ATC SITE NAME: BLACK FOREST
SITE NUMBER: 302460
SITE ADDRESS: 4584 HODGEN ROAD
COLORADO SPRINGS, CO
80908

SHARED GENERATOR PROGRAM ANCHOR TENANT

TITLE SHEET

SITE PLAN

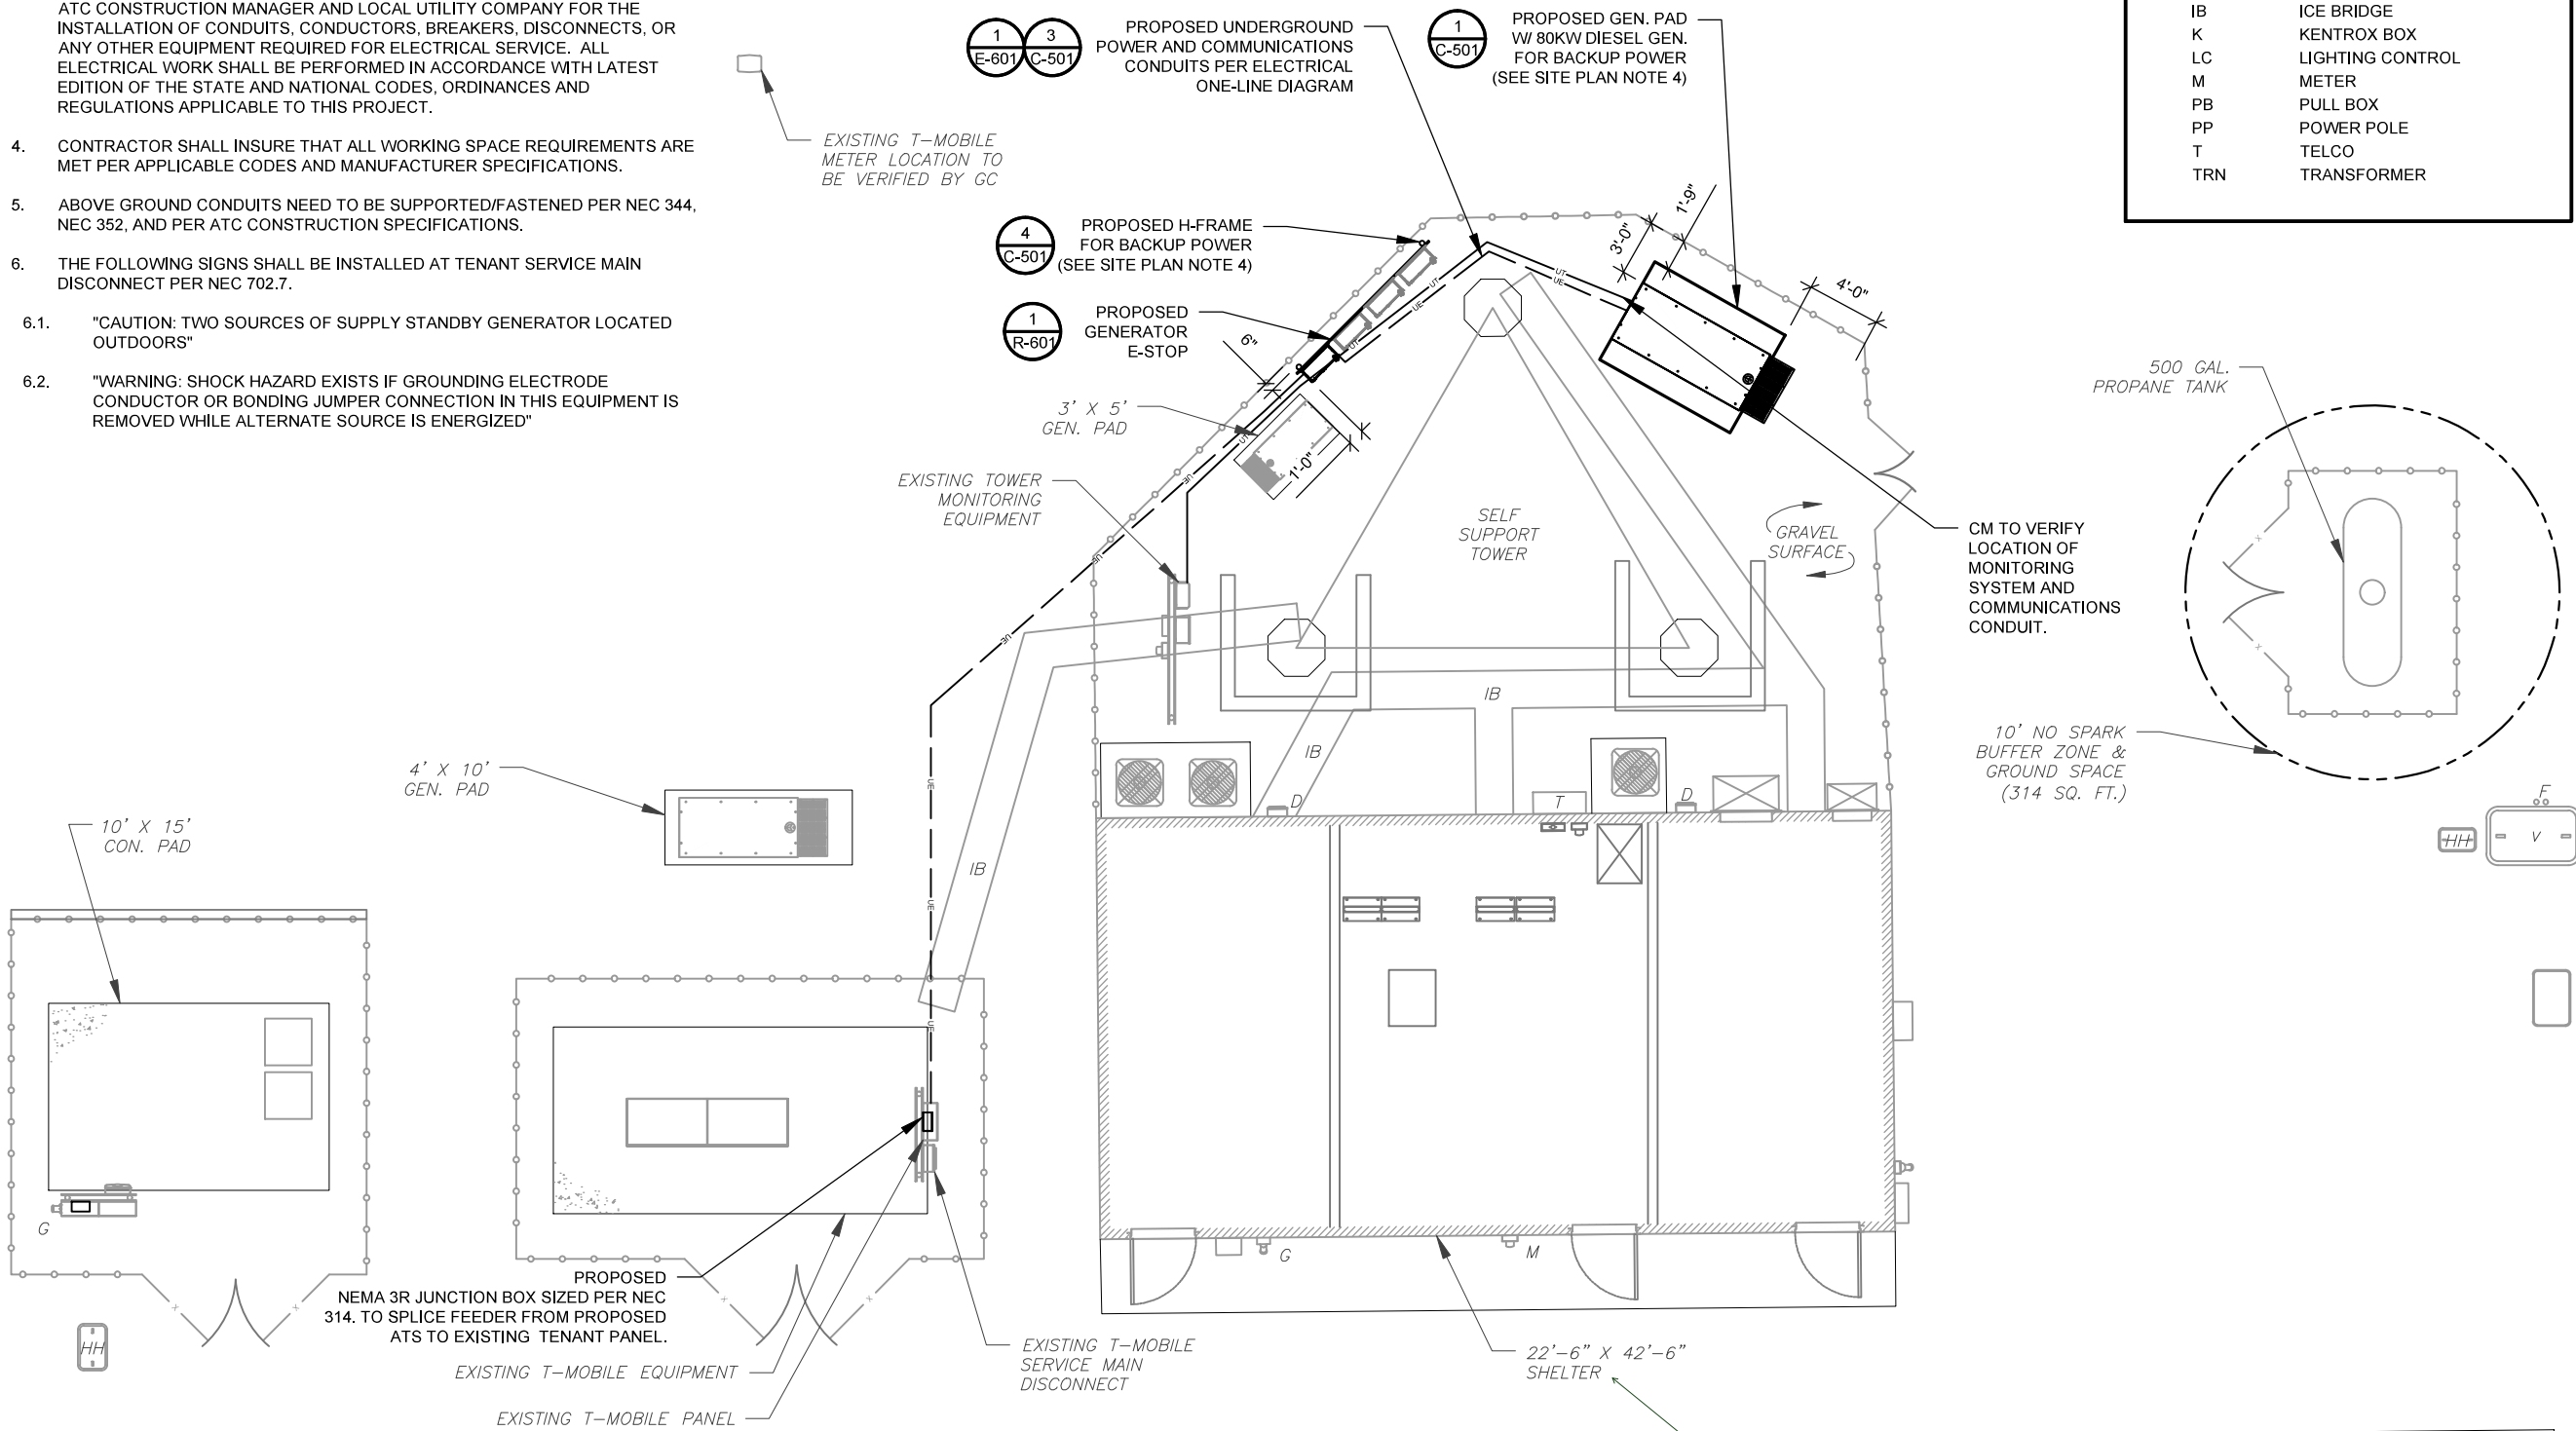
please add project number to site plan

please add dimension to building
so we know which dimension
belongs to which building
